Planning Application Ref: FP/1/19/T

Location: Eaton Lodge, 2 Crossbush Road, Bognor Regis, PO22 7LS

Description of works: Crown reduction 2.5m & Crown thin 25% to 1 no. lime tree and 1 no. evergreen oak tree. Crown reduction 1.5m to 2 no. birch trees

Figure 2 Positions of final cuts

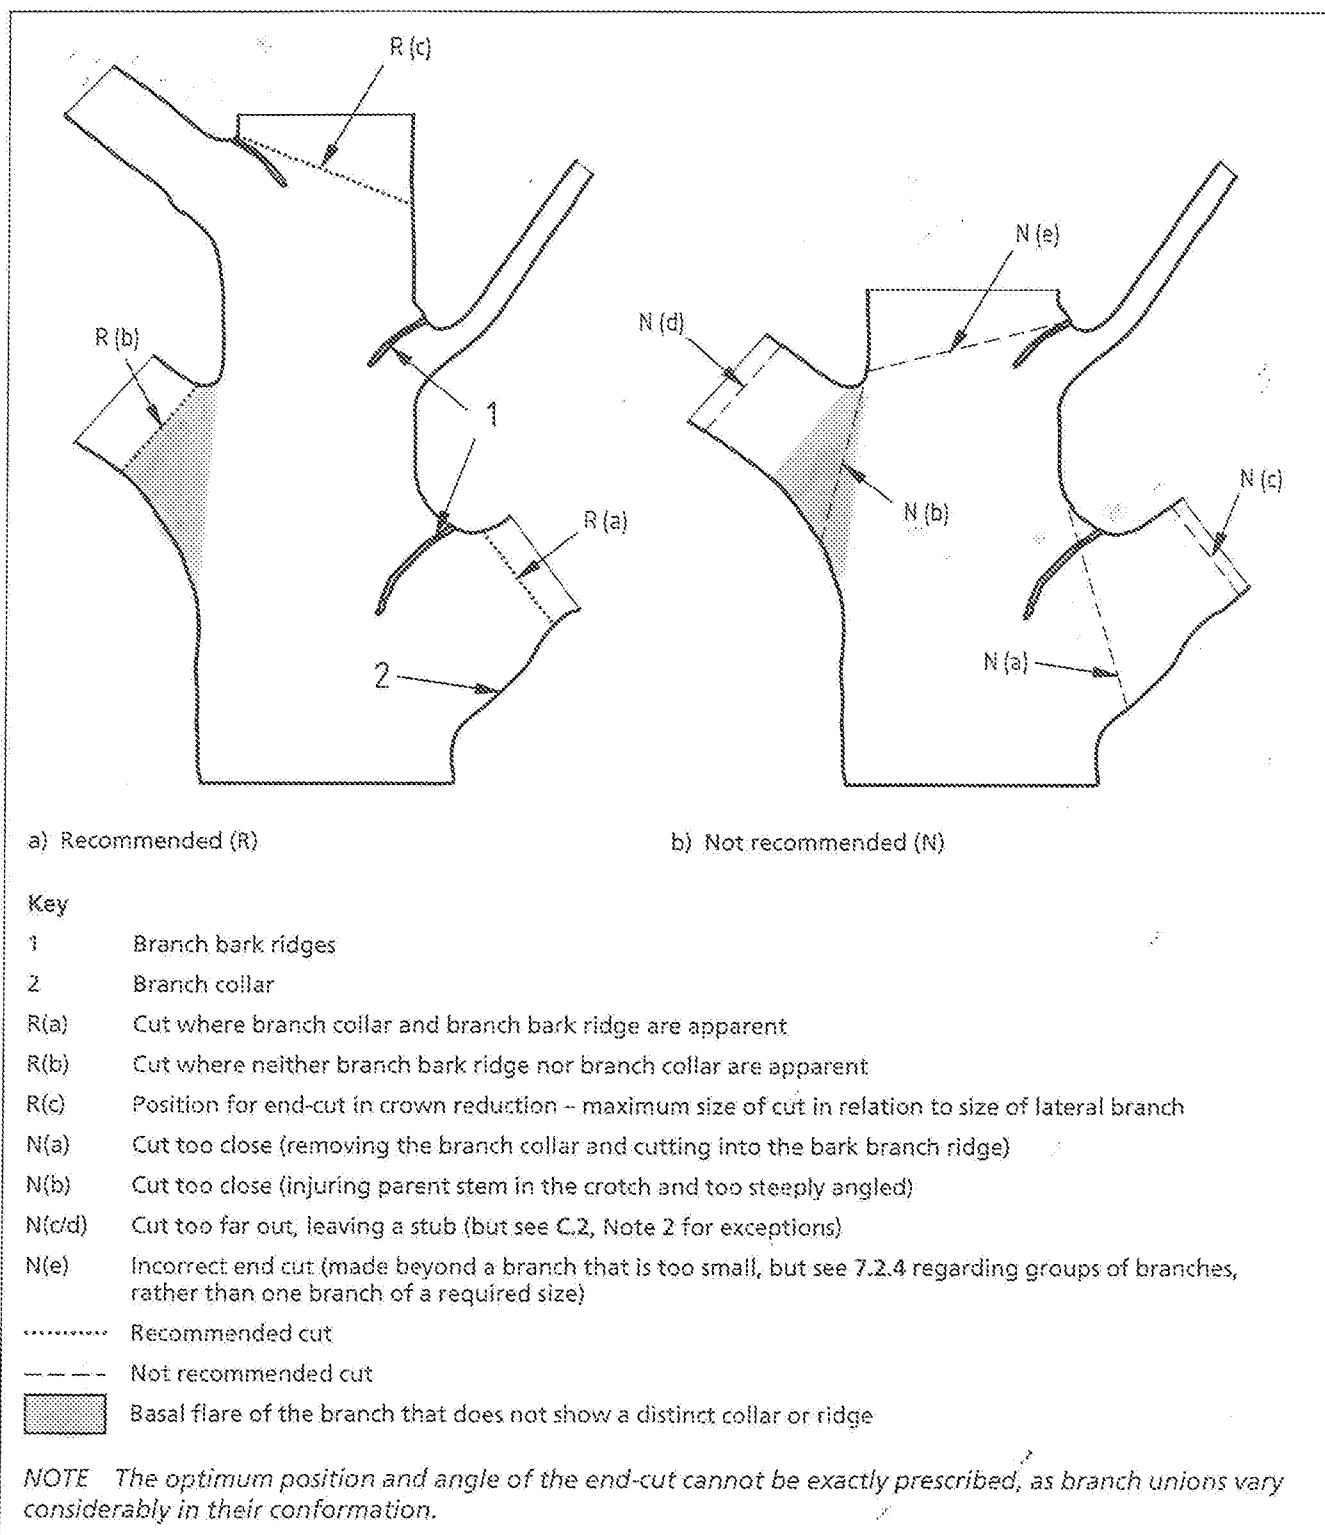
- Where whole branches are to be removed and final cuts made close to the trunk or branch union they are to be made as shown in Figure 2 of BS3998:2010
- Where branches are to be shortened back the final cuts are to be made at the correct angle shown in BS3998:2010 and adjacent to a live bud or lateral.
- The long-term vitality of this tree is best respected when significant pruning work such as proposed, is undertaken during either the summer (June to August) or mid-winter (mid-December to mid-February) periods. The work proposed must only be undertaken during these periods.
